CITY PLANNING COMMISSION

APPLICATION: 1. Environmental Determination
2. Tentative Map
3. Special Permit for 10-Unit halfplex

PROPOSAL: The applicant is requesting the necessary entitlements to develop 10-unit residential condominium project on 1+ acre of land zoned Garden Apartment, R-2A.

APPLC. NO. P-82-089

OUTSIDE ELEVATIONS
EMERY LEISBUM
CHUCK FURBER
5000 SUMNER LANE (916) 944-9347
CANTONMENT, CA 94506

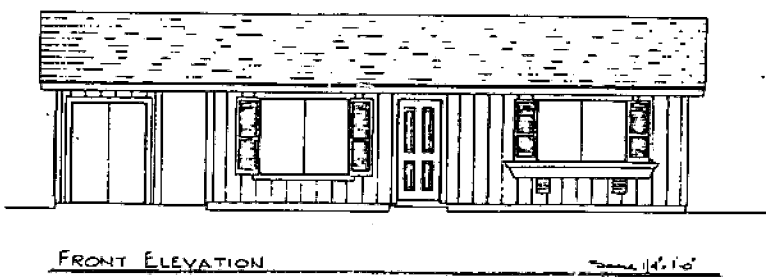
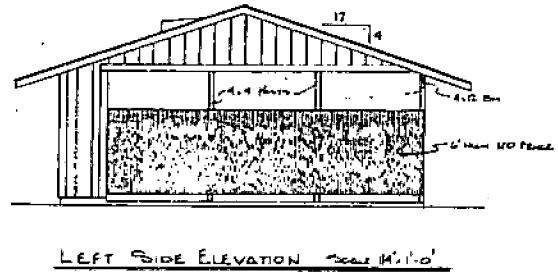
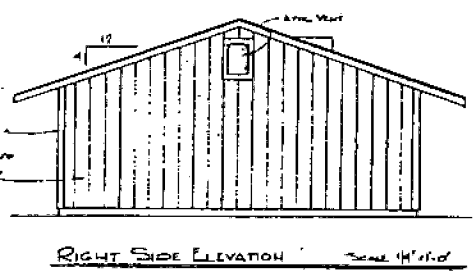
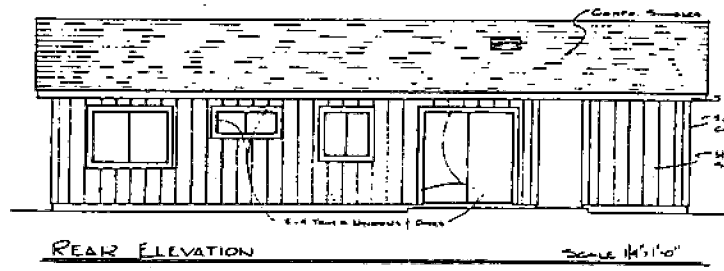
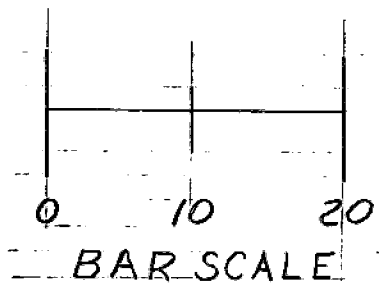
3. The surfaced area can be further reduced by reducing the setback between units one and two and reversing the driveway/garage location of Unit 1.
4. The proposed elevations indicate no windows on the sides of the structures. Therefore, units two and three have no southern exposure for solar space heating. Staff suggests adding a window in each bedroom. For cross ventilation, these additional windows are useful in all of the units. These windows must be shaded from the summer sun for maximum efficiency.

5. Staff has some concerns with the lack of visual interest generated by the outside elevations. It is recommended that these be reviewed by the Design Review/Preservation Board and that their suggestions regarding the elevations and treatment of window shading be incorporated into the plans.

- a. Elevations of the units shall be redesigned to provide additional windows in the bedrooms on the side wall;
- b. Shading treatment for these additional windows, as well as overall elevations, shall be reviewed by the Design Review/Preservation Board prior to issuance of building permits. Suggestions made by the Design Review/Preservation Board shall be incorporated into the plans;

SITE PLAN

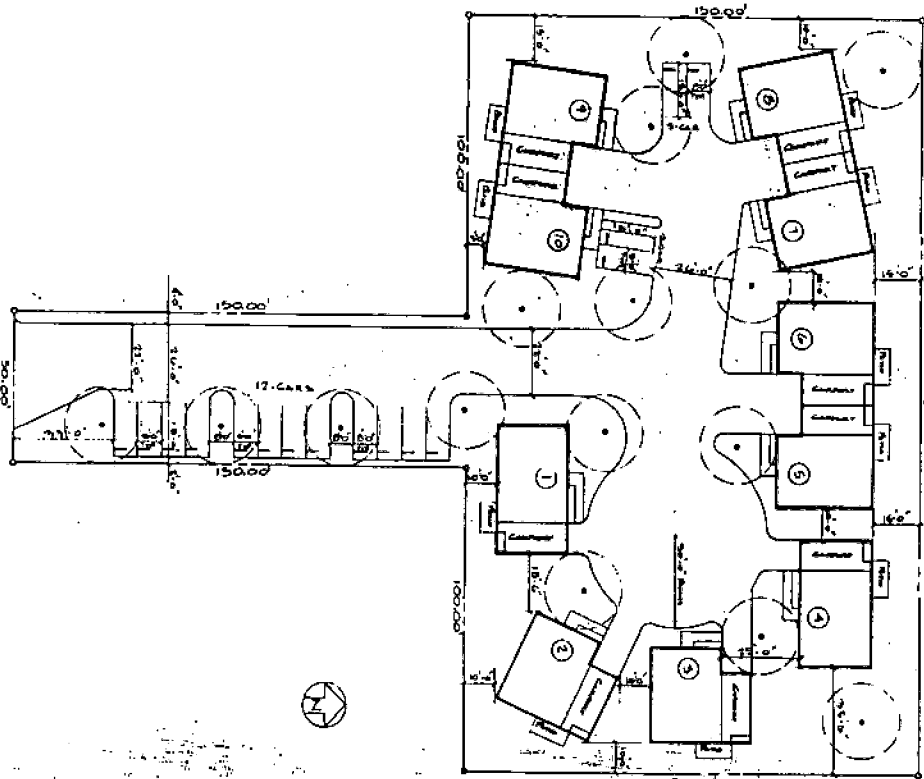
1. The subject site is located in an area consisting primarily of deep lots which are developed with single family residences located near the front portion of those parcels. The entire block is zoned Garden Apartment, R-2A. The applicant is proposing a modest condominium development by combining several parcels which would be difficult to develop if each were done separately. The proposed density of 10 units per acre is well within the R-2A zoning classification, and compatible with surrounding uses. The tentative map combines the parcels and redivides them into one 50' x 150' lot with two existing single family residences and the 1+ acre lot designated for the condominium development. Staff has no objection to the proposed use. There are some problems, however, with the specific site plan of the condominium portion. Staff has prepared an alternative site plan suggesting minor changes which address some of the problems.

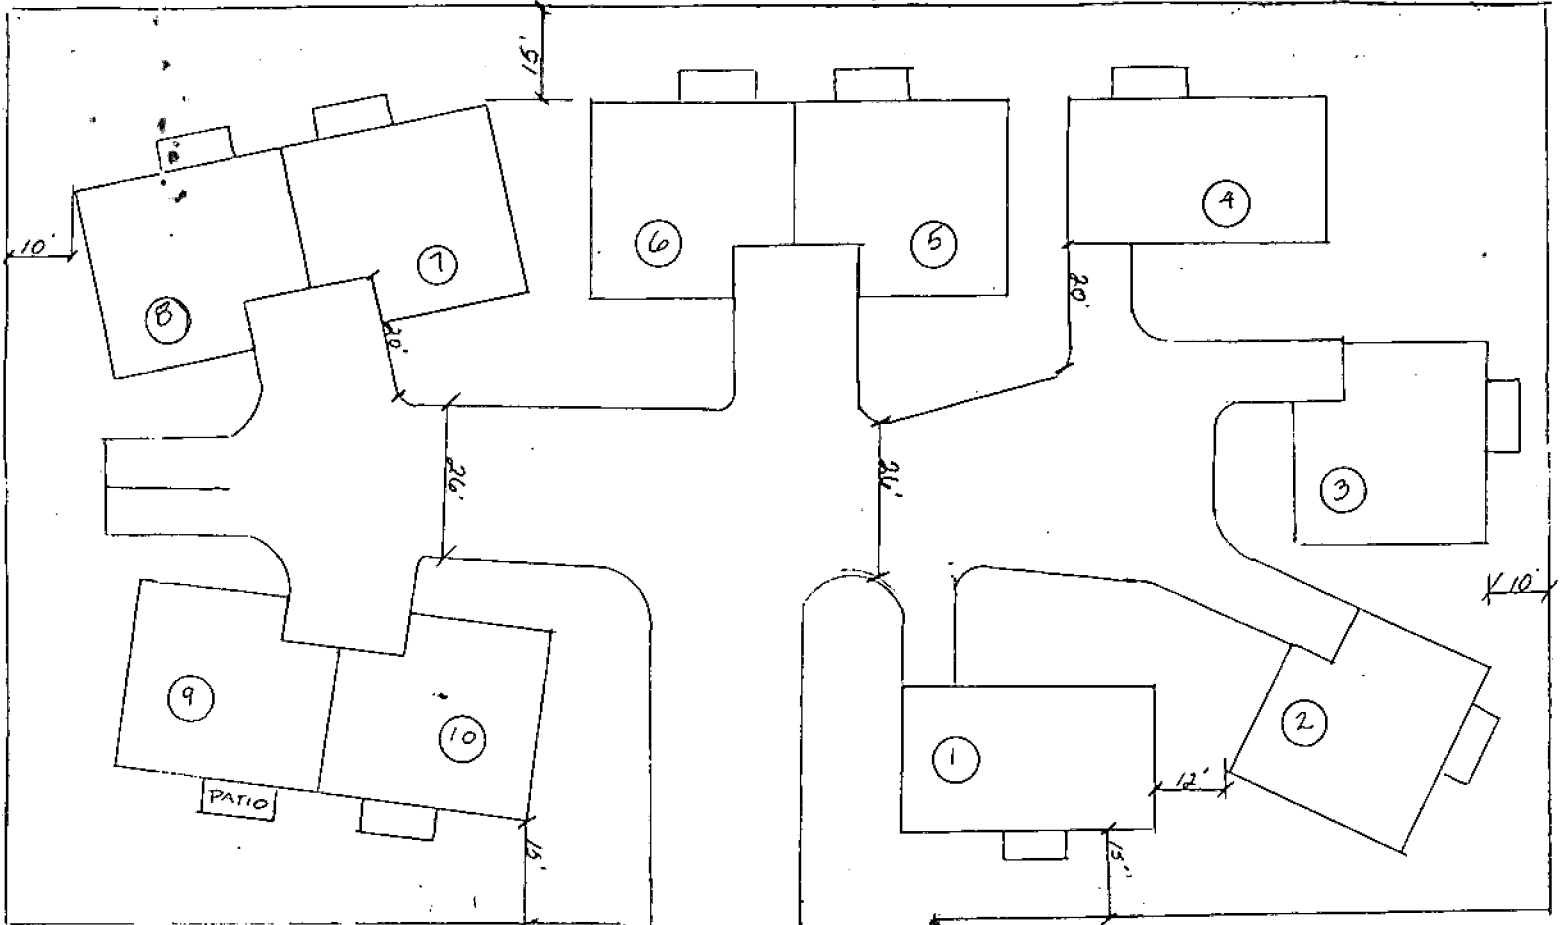
2. Staff's major concern is with the excessive amount of surfaced area in the development which must be shaded, according to the Zoning Ordinance. Staff suggests eliminating eight of the guest parking spaces proposed along the entry drive and reducing the cul-de-sac to a hammerhead (see Exhibit F). Fire Prevention has indicated that staff's proposal provides adequate maneuvering area for access of emergency equipment. Staff further suggests increasing structural setbacks to the property line to 15 feet wherever possible. This will also reduce the amount of surfaced area and the potential impact of the project on the surrounding neighborhood (see also Exhibit F).

8. The project has access from Helena Avenue, and the driveway would be located between two existing single family homes. Staff believes a six-foot high wood fence should be installed on the east and west sides of the driveway to mitigate the noise. (See Exhibit F.)

- c. Detailed landscaping and irrigation plans shall be submitted to the staff prior to issuance of building permits. These plans shall comply with landscaping criteria in Exhibit G. Said plans shall also indicate 50 percent shading of the private parking and maneuvering area.
- d. The units shall be built to the new State Residential Energy Conservation Building Standards, effective July 1982, whether or not said standards become effective.
- e. Conveniently located trash enclosures shall be placed throughout the site as outlined in Exhibit H.
- f. The applicant shall install a six-foot high wood fence as indicated in Exhibit F.

6' Wood Fence

6' Wood fence
